Joint Owners' Group (JOG) Motor Operated Valve Periodic Verification Program Summary

MPR-2524-A, Rev. 1

USNRC SAFETY EVALUATION

Figure 1. Bearing Friction Coefficient for B12.1 with Instrument Measurement Uncertainty

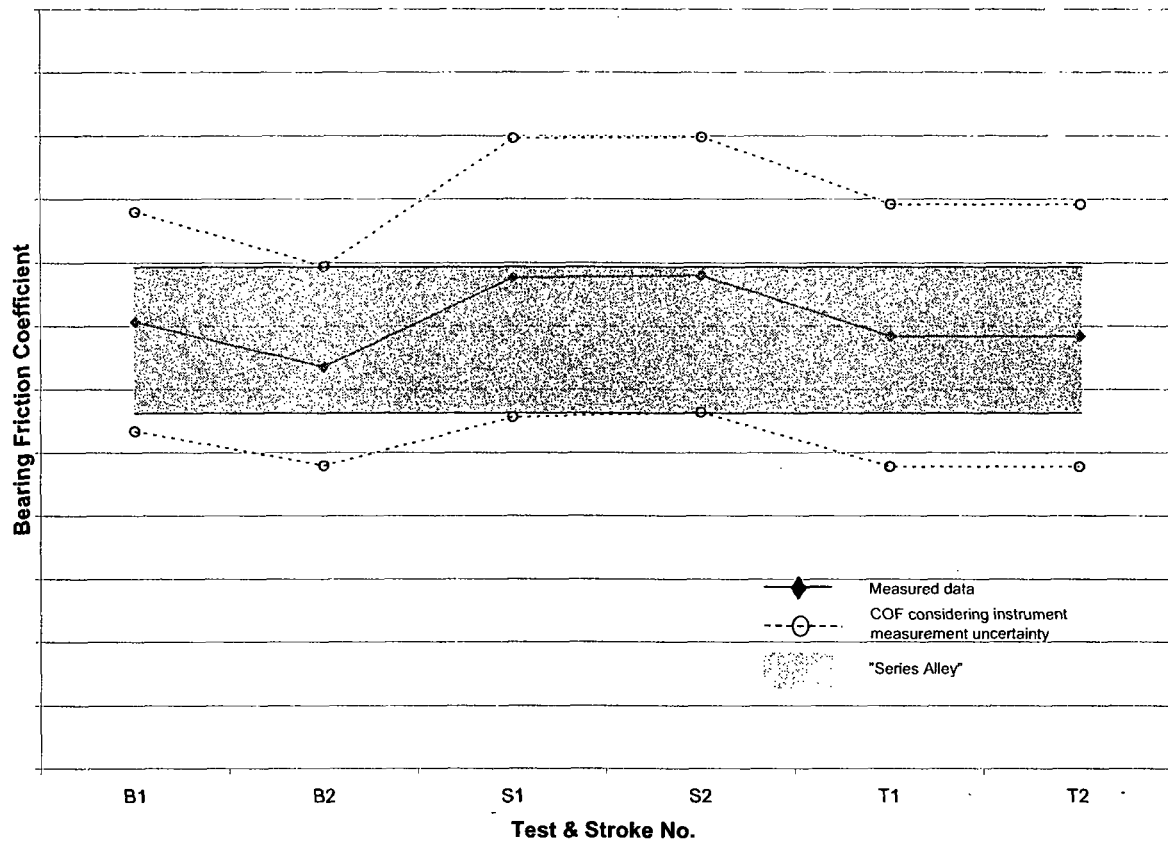
The TR states that the observed decrease in bearing friction coefficient for butterfly valve B11.1 (Figure 4-3) between the baseline and second test is a result of an unusually low static unseating torque (133 ft-lbs) in the baseline test compared to the measured static unseating torque in the second and third tests (213 to 224.5 ft-lbs). The JOG also indicates that the unseating behavior is more consistent across the three tests as seen in the overlaid dynamic torque traces. The differential pressure (DP) torque overlay traces do show a small decrease in DP unseating torque between each test; however, the JOG states that the DP torque for all three tests is almost identical at the beginning of the stroke. The JOG concluded that, based on the DP torque overlay plot, the change in bearing friction from baseline to second test is attributable to the unusually low static seating torque in the baseline test and that the bearing friction behavior was therefore stable across the three tests. Since it was not possible to discern the dynamic unseating torques values from the torque overlay traces in Figure 4-3, the JOG provided the dynamic and corresponding static unseating torque values for all B11.1 valve test series during the audit. When compared, this data showed that the behavior of the dynamic unseating torque was consistent with the behavior of the corresponding static unseating torque values. Like the static test data, the baseline dynamic unseating torque was also significantly lower than the second and third tests series. It is not clear that the dynamic torque data alone suggests that the observed coefficient of friction (COF) change between the baseline and second test was not valid. Also, it is not clear from the discussion in the TR that other potential reasons for the observed increases in static unseating torque were addressed. Please provide additional discussion regarding the interpretation of these results, the potential causes considered and the evaluations performed by the JOG to support the conclusion regarding the validity of the baseline test data.

The JOG tested four butterfly valves with bronze bearings in treated water. In general, the observed changes in bearing friction coefficient between tests are within the band of instrument uncertainty, as exemplified by the results for B12.1 shown below in Figure 1. However, there are two exceptions to this observation, as discussed below.

In one exception, one of six data points for valve B13.1 fell just below the band of instrument uncertainty. Since this point was a repeat stroke of the baseline test and since the five other points all fell within the uncertainty band, this exception has negligible impact on the conclusions of stable bearing friction for the valve. The other exception is the baseline test results for valve B11.1. This result is expected, however, since the baseline data was determined to be conservatively high, creating an apparent large change from the baseline to second test.

Overall, the evaluation of measurement uncertainty, in addition to the average bearing friction result from all four valves, supports the conclusion that the bearing friction coefficient for butterfly valves with bronze bearings in treated water is stable.

Figure 2. Valve Factor vs. DP Stroking for Gate Valves with Stellite Seats in Steam

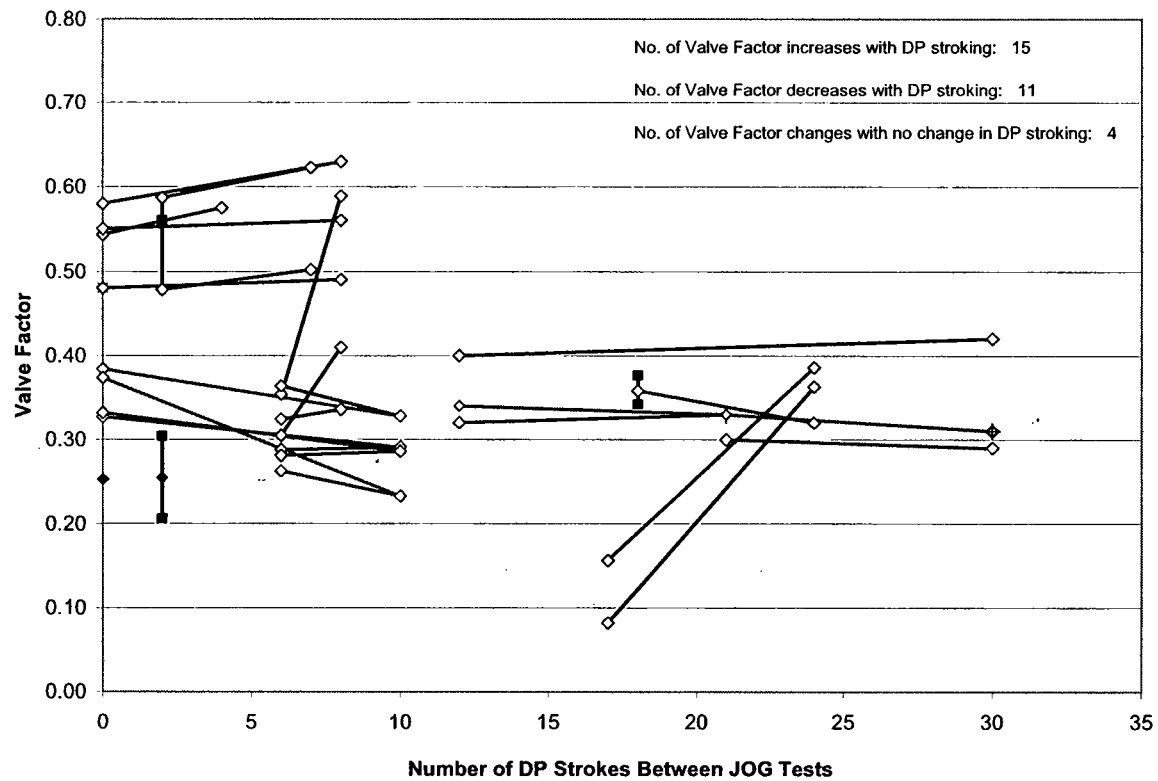
- (1) The JOG does not agree with the observation that, for valves in steam, lower DP stroking correlates to higher friction and more frequent DP stroking correlates to lower friction. As shown in Figures 3-21 and 3-22 of MPR-2524, there is a mixture of behavior for valves with "low" DP strokes between tests. Note that Figure 3-22 incorrectly identifies valve G41.07 with regard to its stroking frequency. As shown in Table 3-2, this valve is a "low" stroking valve and should be indicated on the Figure with a long dashed line. In addition, the two plots in Figure 3-22 do not identify the single data points for G41.06 and G41.07 as values for low stroking valves. When these data are appropriately considered, a potential trend between stroking and valve factor is weak. For the one valve with "no DP stroking," (G60.05) the data do show valve factors among the highest values observed. However, even these data do not support a trend. This valve had no DP stroking prior to the baseline and third tests, but did have several DP strokes between the baseline and second tests. The highest valve factor was observed in the second test (after stroking); lower valve factors were observed in the other tests (without prior stroking).

considered the specific number of DP strokes between tests rather than using the qualitative DP stroking categories, as this approach provides a more precise account of the effect of DP strokes from test to test. Figure 2 (attached) presents the data for Stellite valves in steam from Figures 3-21 and 3-22, with valve factor (1st stroke) on the y-axis and the number of DP strokes preceding the test on the x-axis. The baseline test results for G60.01 and G60.05 are not included in the analysis, as the baseline valve factors are affected by valve disassembly. Where a valve has results from 2 or more tests, the valve factor data are connected by a line segment. Line segments that travel up and to the right on the plot (southwest to northeast) indicate that valve factor tends to increase with DP stroking. Line segments that travel down to the right (northwest to southeast), indicate that valve factor tends to decrease with increasing DP strokes. Vertical line segments indicate valves that had the same number of DP strokes prior to the test. As the figure shows, the results are mixed. In 15 cases, the valve factor increases with increasing stroking. This result is similar to the behavior for valves in cold water systems. In 11 cases, the valve factor decreases with increasing stroking. In 4 cases, the line segment is vertical and no determination of the effect of increasing DP strokes can be made. In total, the results do not support the trend identified in the NRC comment and do not suggest or imply that there is age-related degradation.

- (2) The JOG does not agree with the observation that valves in steam which stroked back-to-back within a given test showed lower friction in the second stroke compared to the first stroke. As shown in Figures 3-21 and 3-22 of MPR-2524, out of 30 repeat strokes (e.g., B1 to B2), 16 showed a decrease in valve factor while 14 showed an increase or stable valve factor. As discussed on page 3-42 and Figure 3-76 of MPR-2524, the average change was a very slight decrease. These results do not support the expected behavior if age-related degradation were present.

- Revise Figure 3-22 on page 3-89 to correctly identify the DP stroking category for G41.07.
- Revise the observations related to DP stroking for gate valves in steam in the 2nd paragraph on page 3-18 to be consistent with the conclusions presented in the comment response above.
- Revise the observations related to DP stroking for gate valves in steam in paragraphs 1 and 2 on page 3-41 to be consistent with the conclusions presented in the comment response above.
